Planning and Zoning Commission Meeting - Regular AGENDA

2. Bluebird Village Community Housing Project, P 21-027 Pre-Design Review

**STAFF REPORT
KETCHUM PLANNING AND ZONING COMMISSION
REGULAR MEETING OF MAY 11, 2021**

PDR L1.04

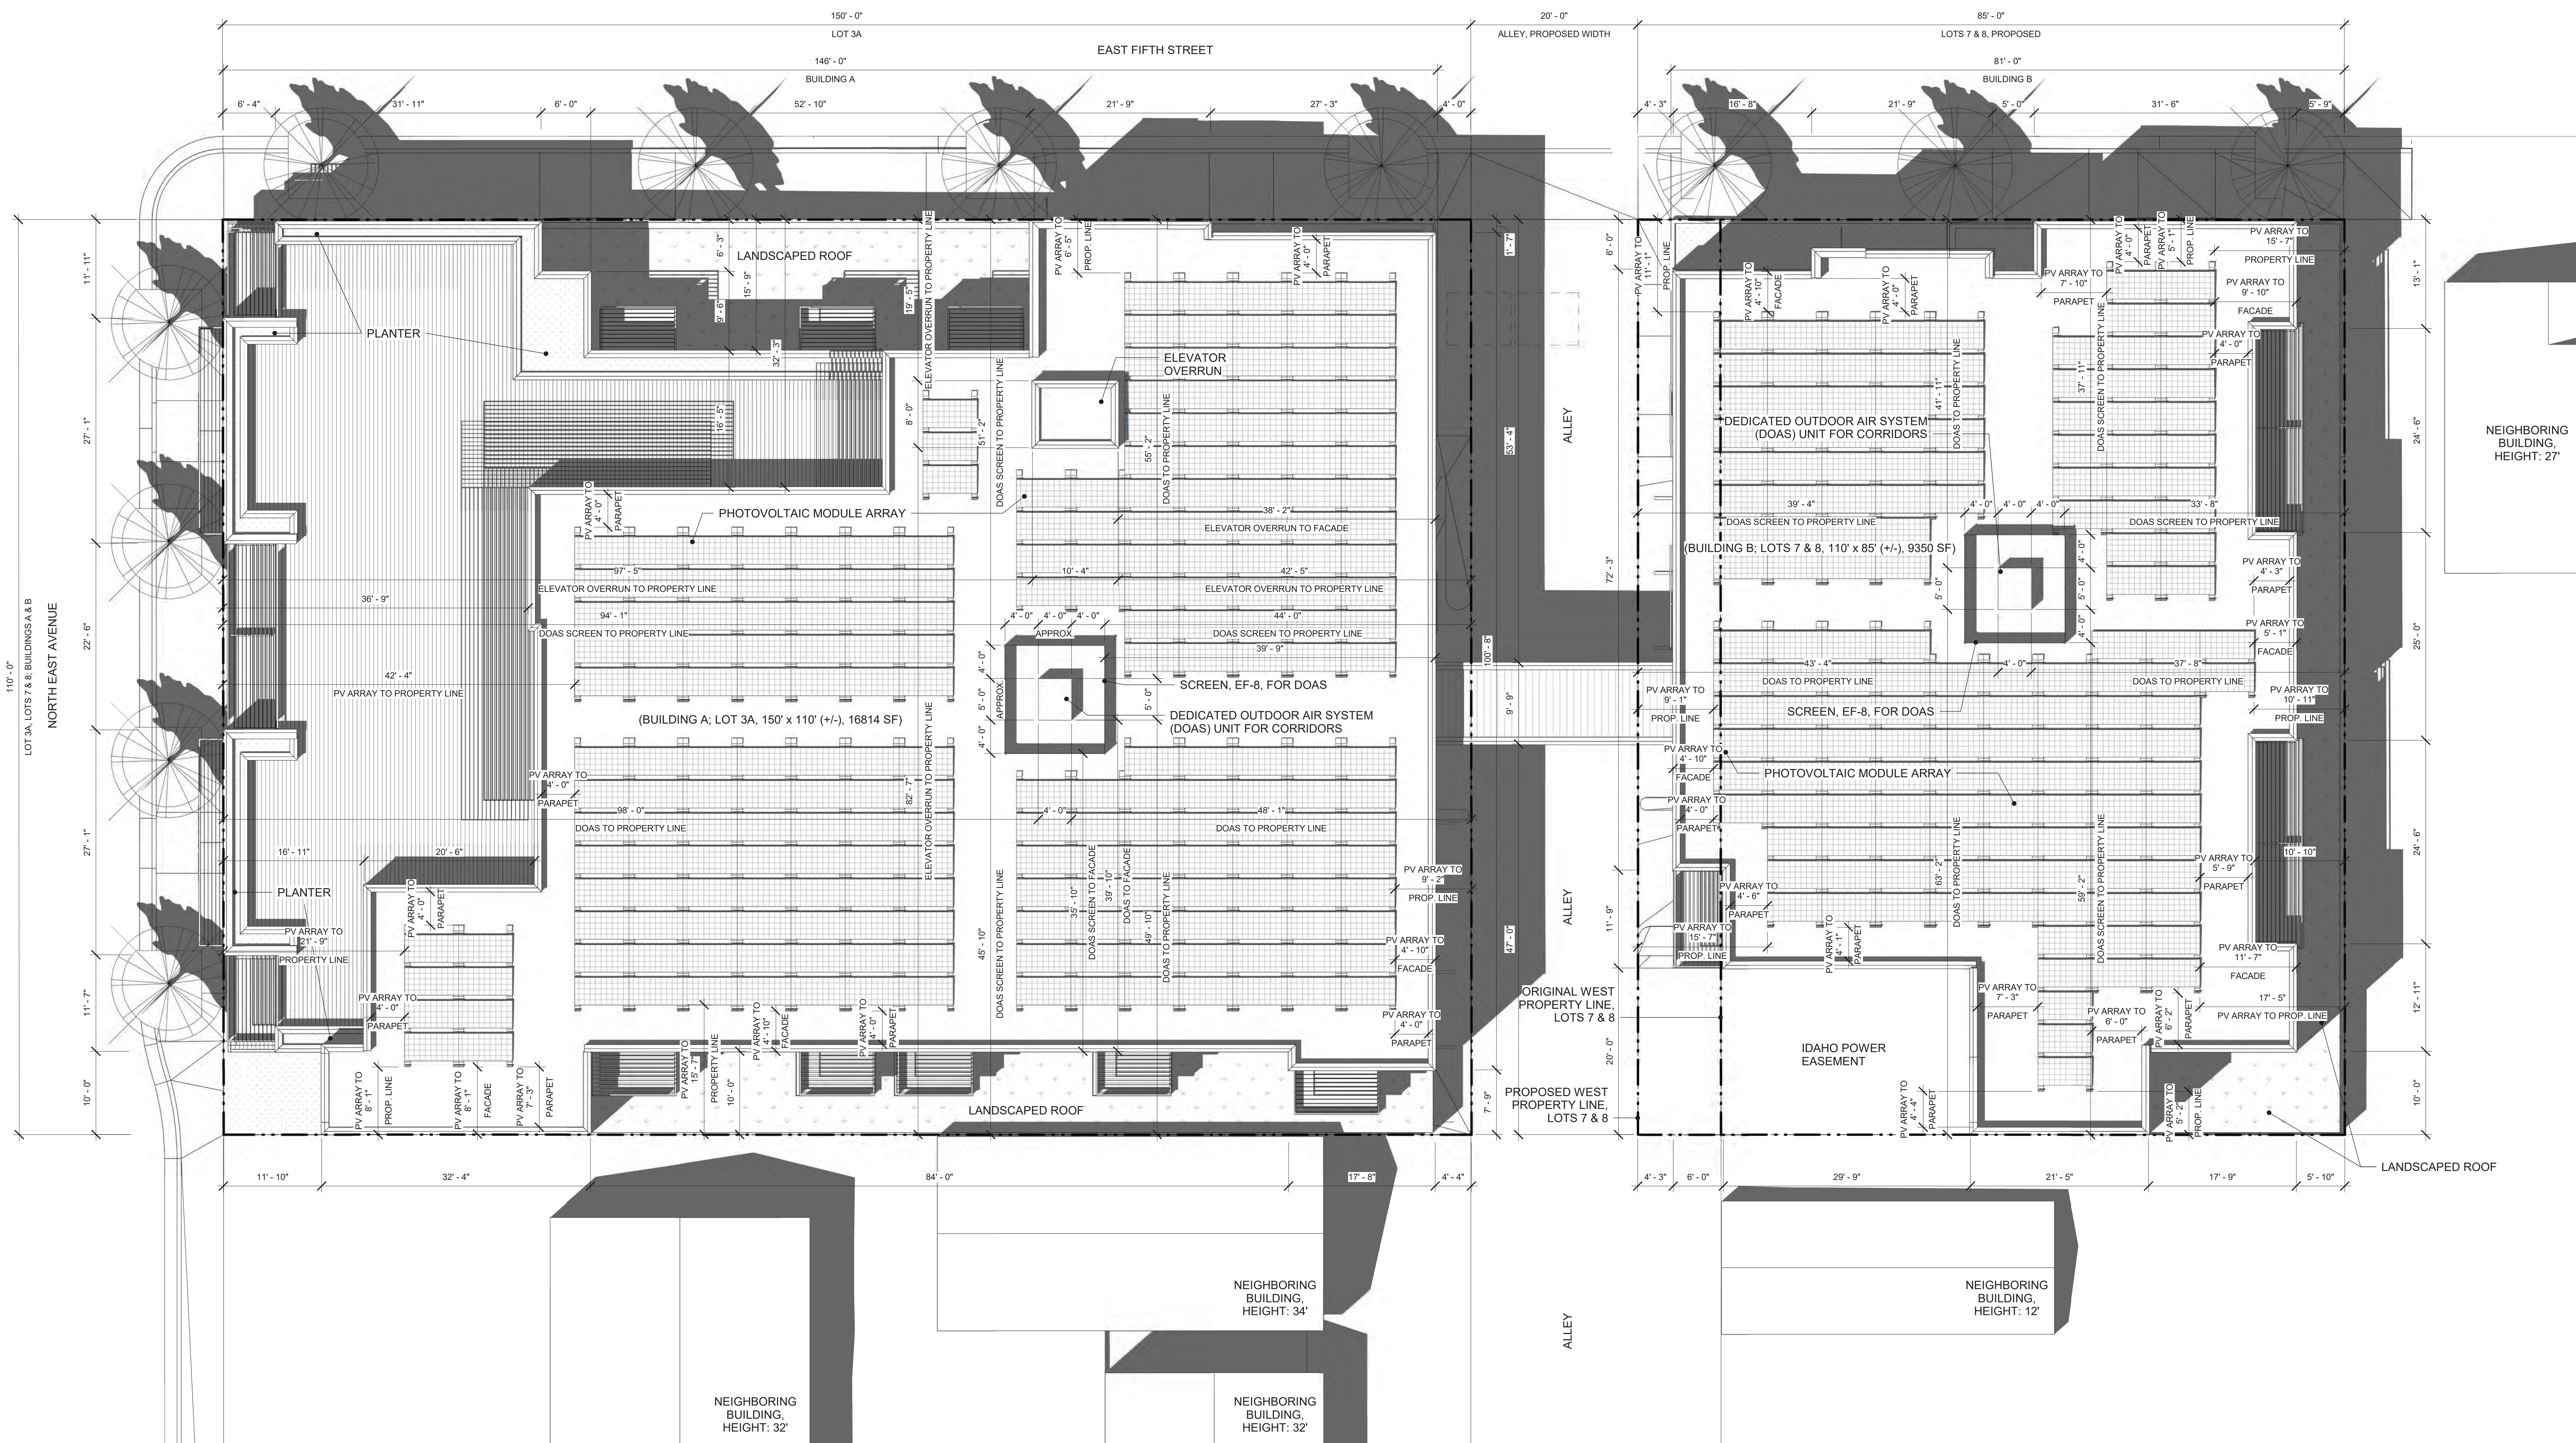
| | | | | Street define the building entrances. Sheet PDR L1.02 shows landscaped roofs provided at the wall setbacks along 5 th Street, the south interior façade, and the east rear façade. Sheet PDR L1.04 shows the landscaped screening provided at the roof deck, which includes 6 trees and perennial beds. |

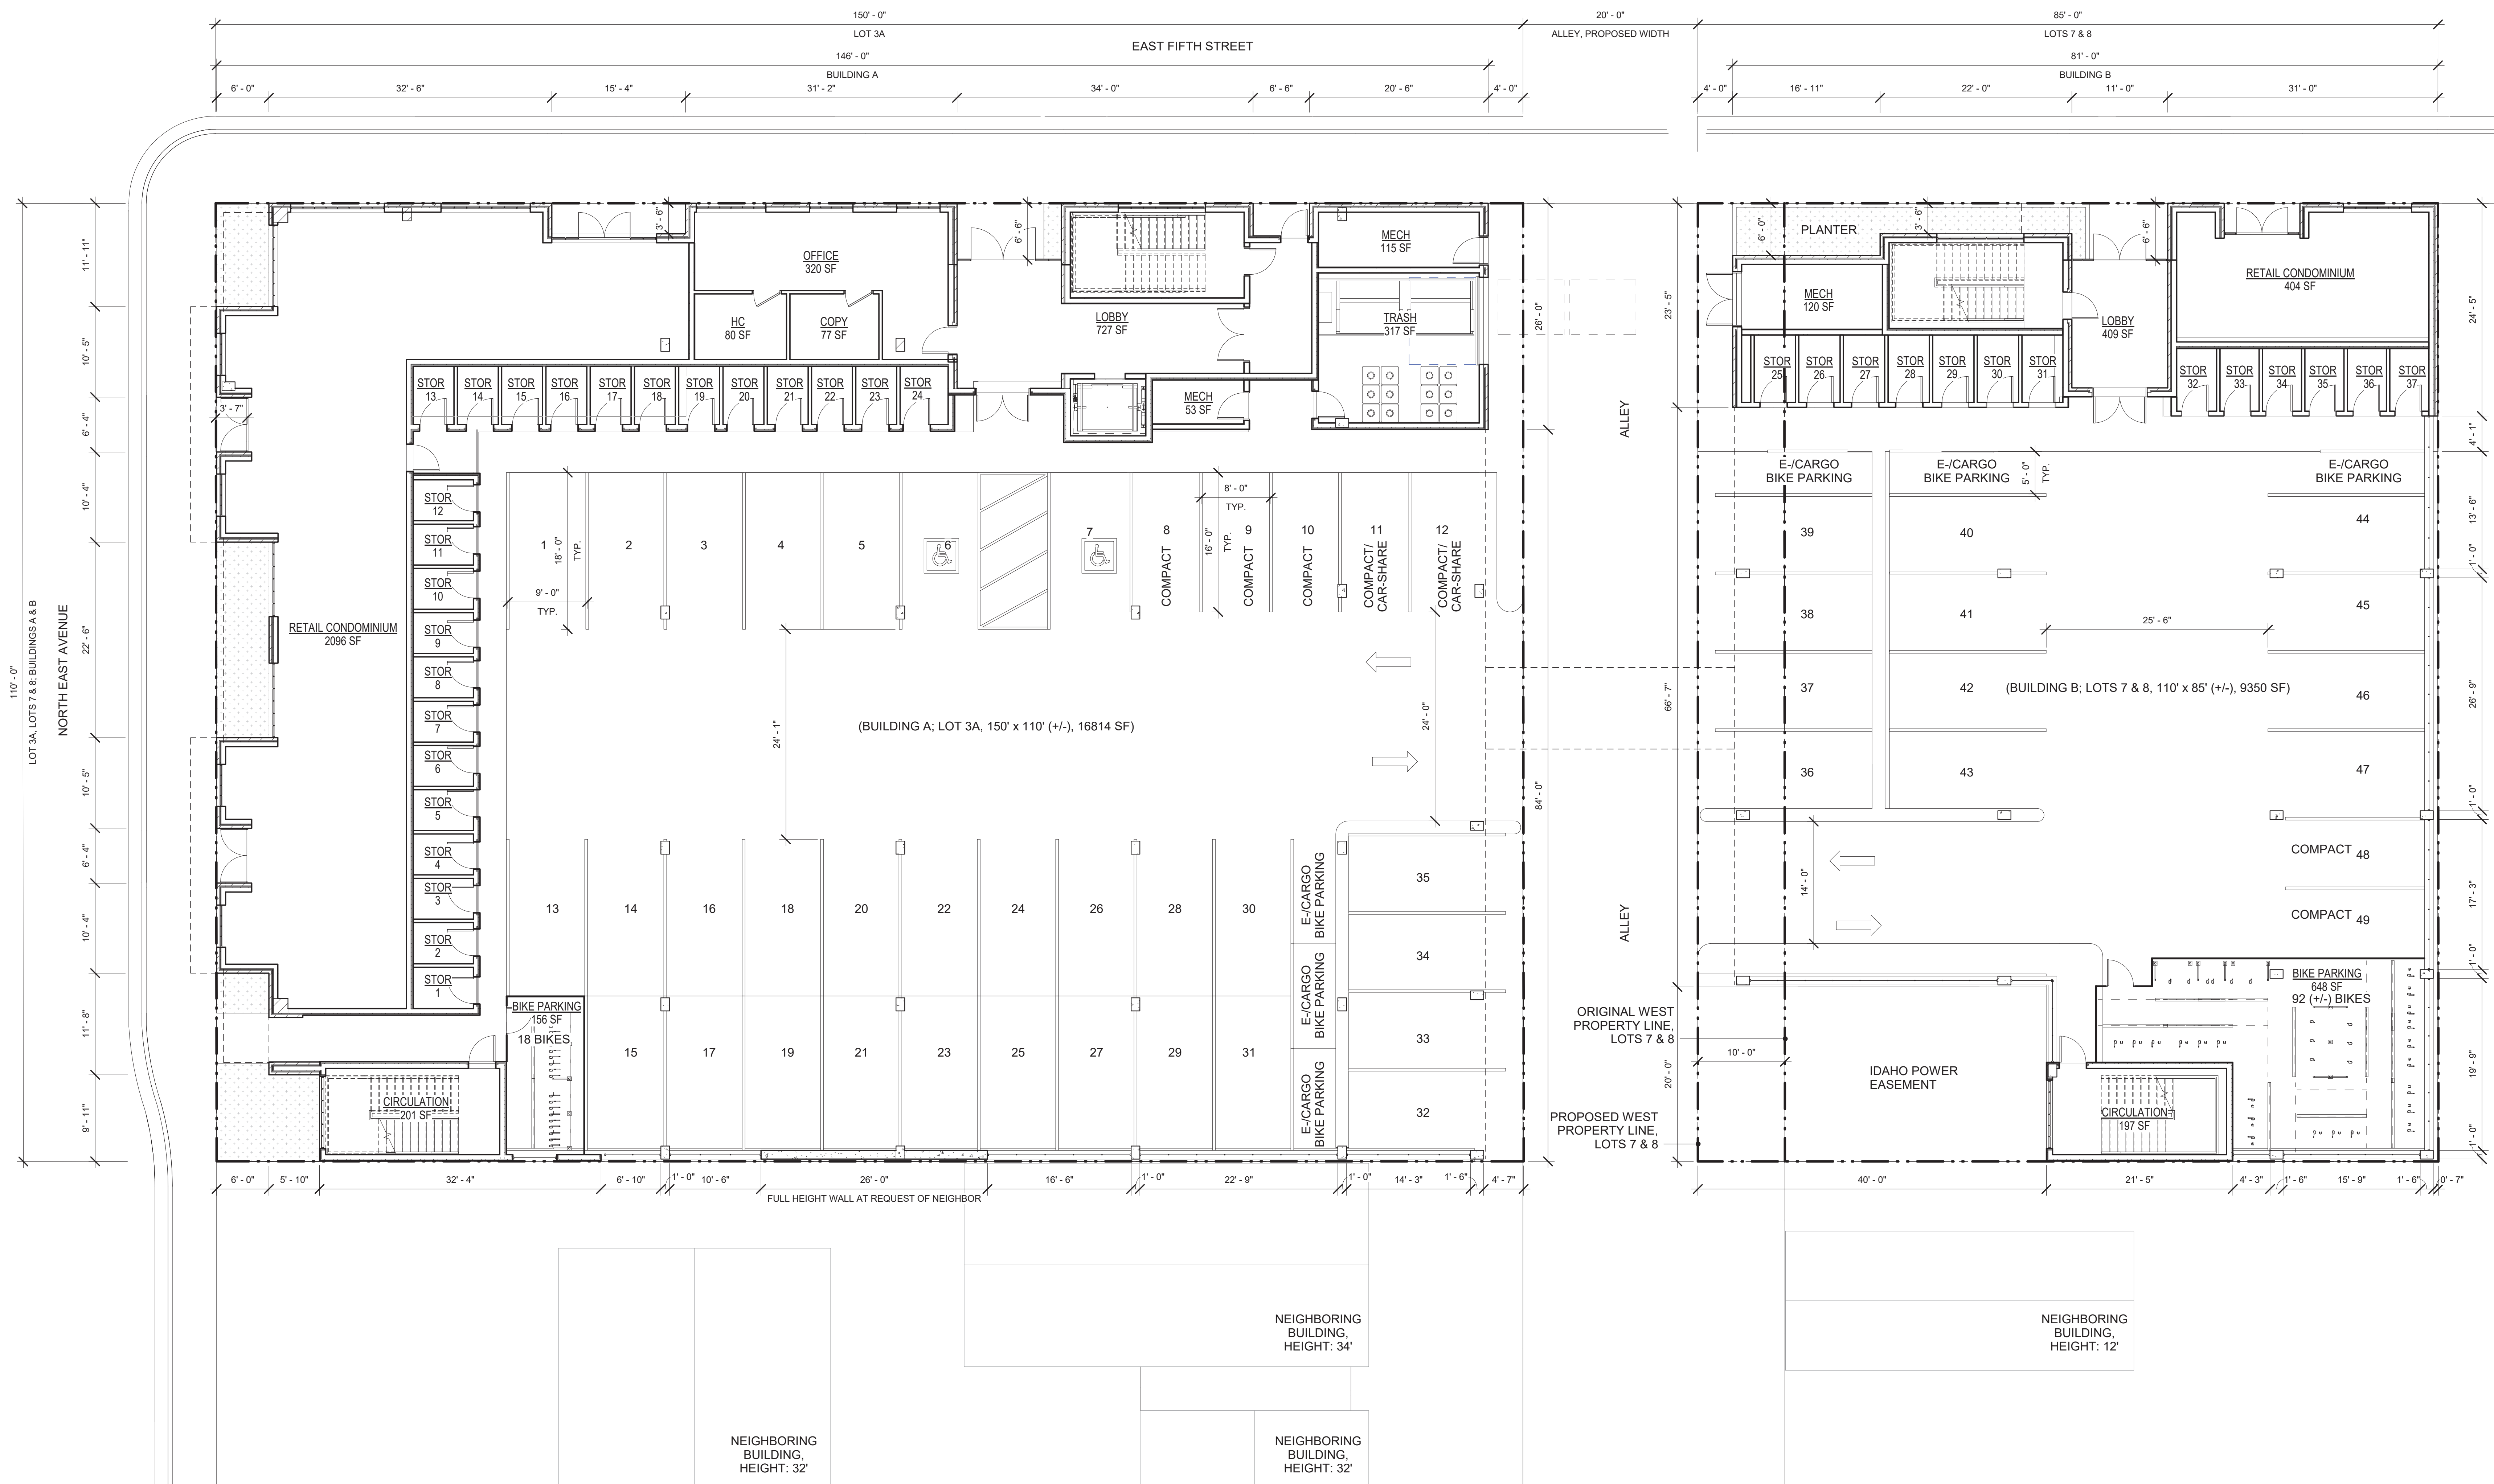
| | | | Staff Comments | The architectural site plan on Sheet PDR A1.01 notes: <i>No viable on-site snow storage areas. Snow management to be accomplished by snowmelt and hauling snow off-site.</i> The applicant proposes to snowmelt or haul snow off-site, which is permitted as an alternative to providing a snow storage area by KMC §17.96.060.H4. |
| | | | Staff Comments | The architectural site plan on Sheet PDR A1.01 notes: <i>No viable on-site snow storage areas. Snow management to be accomplished by snowmelt and hauling snow off-site.</i> |
